**AGENDA**  
**HISTORIC PRESERVATION BOARD**  
City Commission Chambers  
October 26, 2023 8:30 A.M.

**AGENDA**  
**DESIGN REVIEW COMMITTEE**  
October 26, 2023

- B. [HPB23-176 – 1124 Hartsell Avenue](#) – Final Approval requested for the new construction of a single-family house on the vacant subject property. Owner/Applicant: Orbe Construction, Inc.

**WINDOW & DOOR HISTORIC DETAIL**

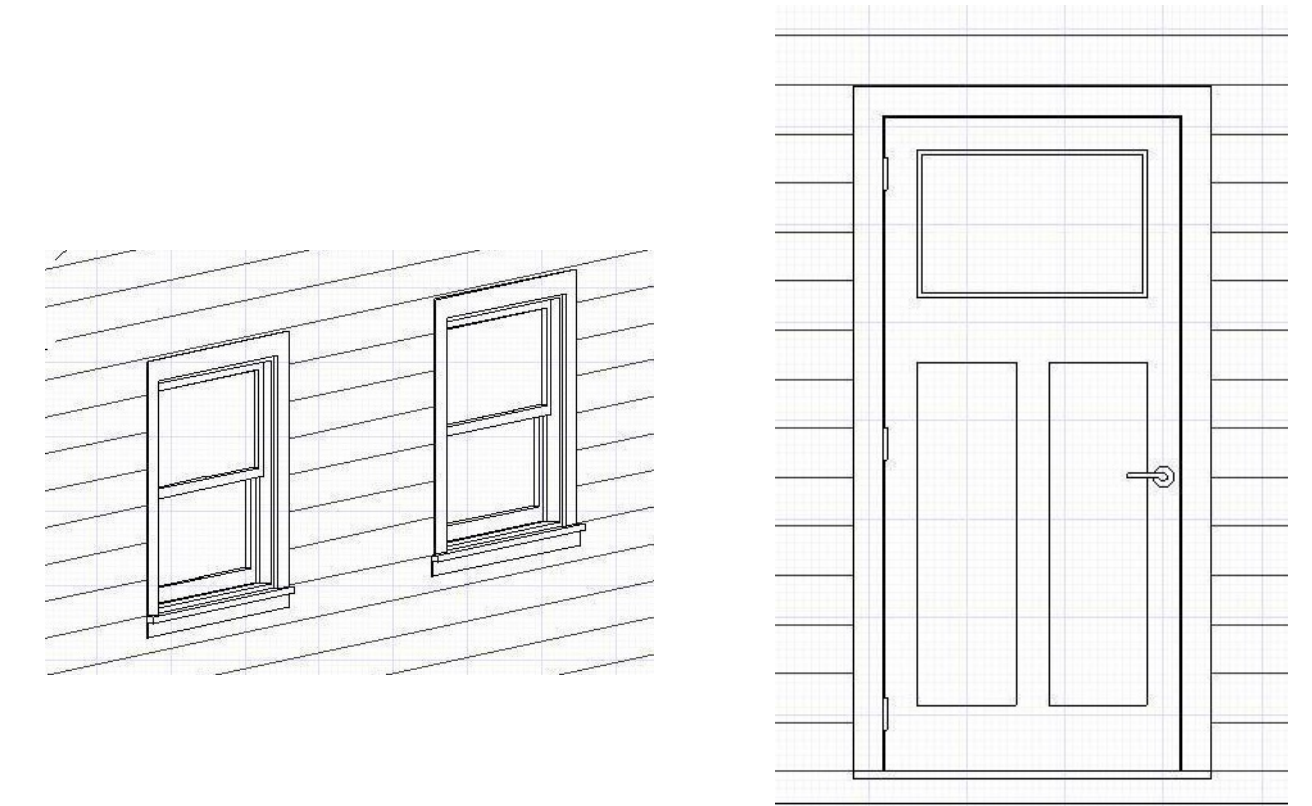
1. Windows must be recessed to provide a shadow line and not installed flush to the exterior wall surface and exterior-mounted muntins/grids are required.
2. Submittal of materials list for fascia, soffit, and exterior doors.
3. Submittal of a complete exterior paint palette.

RENOVATIONS FOR:  
**GARAGE APARTMENT**  
1928 SHAWNEE TRAIL, LAKELAND, FL 33803  
**PROPOSED SITE PLAN**

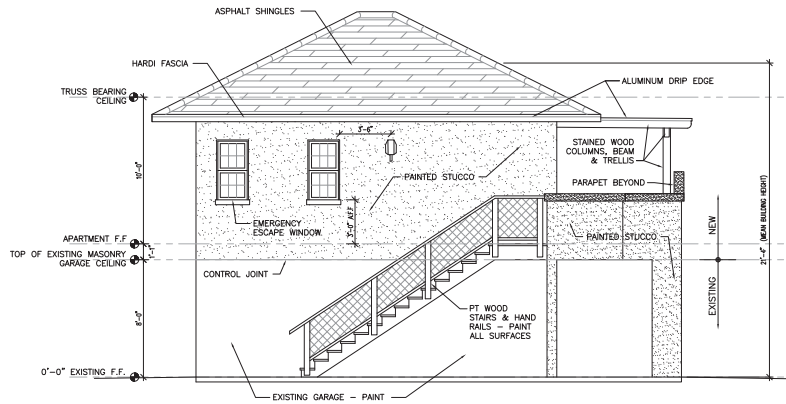
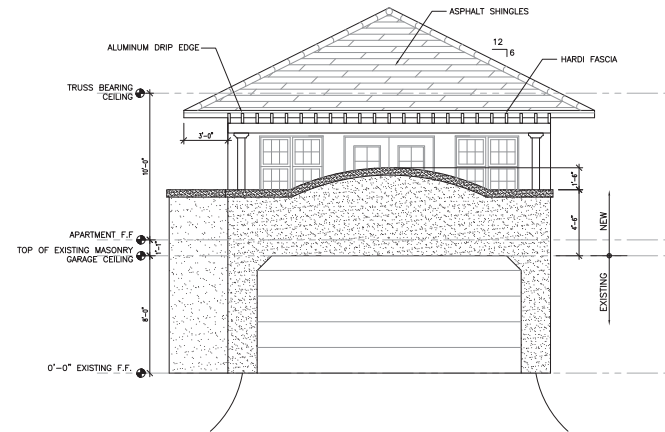
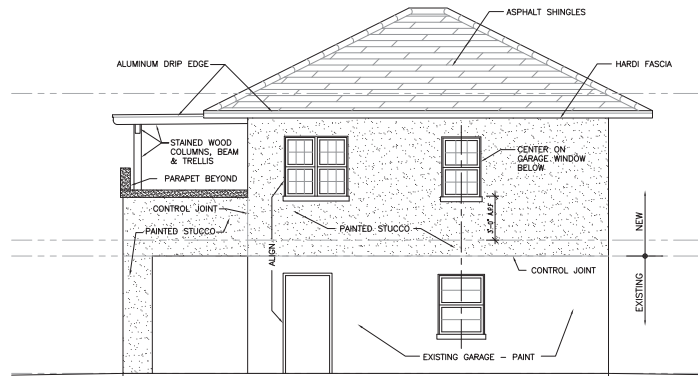
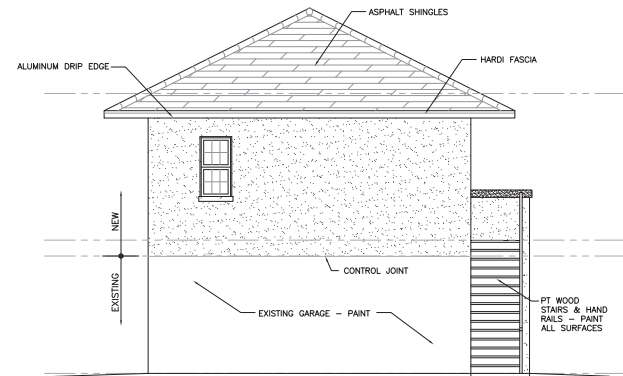
- a. Must be installed with a recess to provide a shadow line instead of installed flush with the exterior wall.
  - b. Must utilize exterior mounted muntins/grid.
2. For the trellis roof, either 5V crimp or standing seam metal roofing must be used instead of corrugated metal panels for consistency with the Design Guidelines.

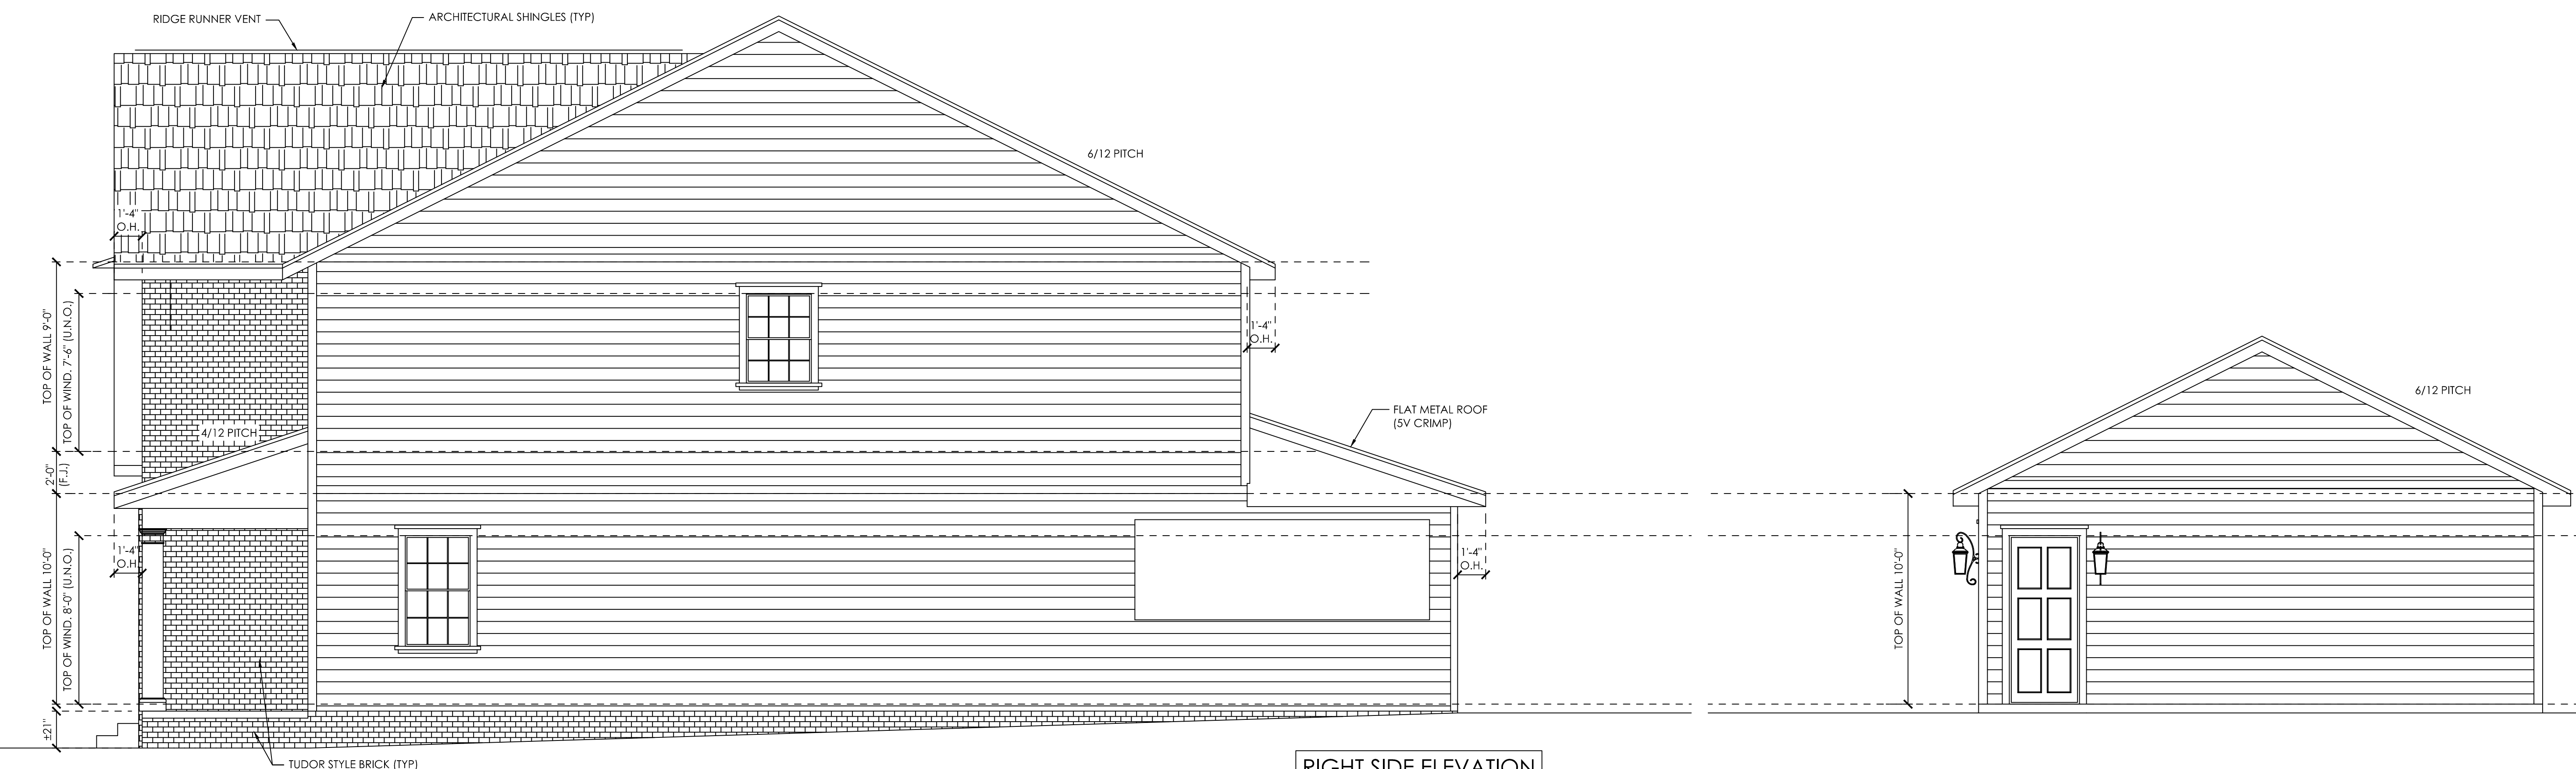
1. Windows:
  - a. Shall be recessed from the exterior wall face to the exterior window glass to provide a shadow line. Flush-mounted windows are not permitted.
  - b. Simulated divided lite windows shall have dimensional, exterior-mounted muntins; paired or grouped windows shall have a dimensional muntin matching the casing.
2. Use flat panel 5V crimp metal roofing, not the type that is striated between V crimps/seams.
3. An exterior paint color palette must be submitted, to include paint manufacturer, color code, and color names for body, trim, and accent colors, if applicable.
4. Increase the street side (front) building setback of the house to 28 feet.
